QUALITY ASSURANCE -- NON-CONFORMANCE REPORT

Report No: NCR-000514

Reference Description: Heat Straightening not according to the Heat Straightening Procedure on Crossbeam
 8

Job Name: SAS Superstructure
Document No: 05.03.06-000477

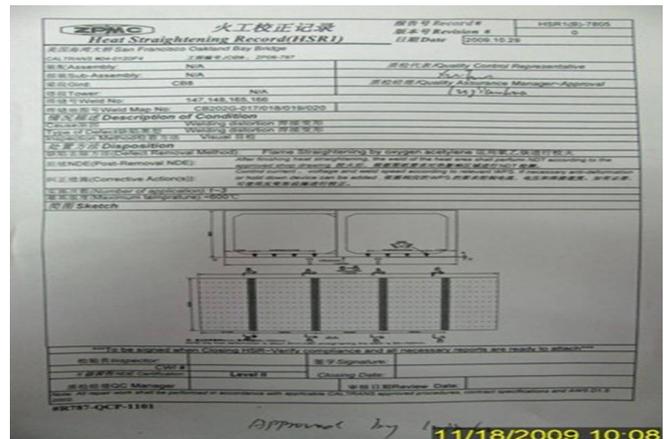
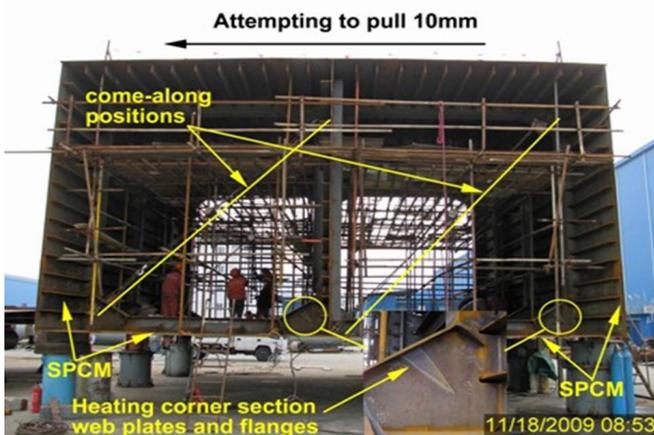
This Quality Assurance (QA) inspector observed ZPMC personnel attempting to correct an “out of square” condition on OBG crossbeam CB8. According to ZPMC Quality Control (QC) inspector identified as Mr. Liu Cheun Gang, this crossbeam was fabricated 10mm out of square. This QA noted that all welding has been completed on this crossbeam. This QA observed ZPMC personnel rigging hand operated winches (come-alongs) diagonally, top to bottom, inside of the crossbeam at two floor beam diaphragm locations on each side of the intermediate diaphragm panel. This QA also observed that ZPMC appears to have heated the web and flange plates on the floor beam diaphragm corner sections. These procedures and the description of the distortion were not documented in the two Heat Straightening Records HSR1(B)-7466 and 7805 dated 8/25/2009. The work performed is not in compliance in the ZPMC internal approved HSR documents.

HSR1(B)-7805

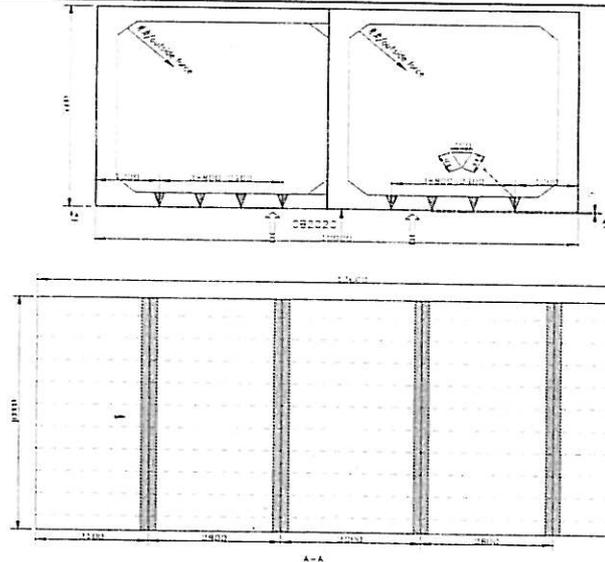
The provided HSR1 does not accurately reflect the locations where heat was applied and which welds have been affected. As discussed, please provide a revised HSR1 accurately describing 1) the methods used, 2) the locations of heat application, and 3) the welds affected by the head application/straightening.

ZPMC is providing the revised HSR(1)s what show the methods used for the heat straightening. Based on the previous response and the attached documentations, ZPMC is requesting closure of this NCR.
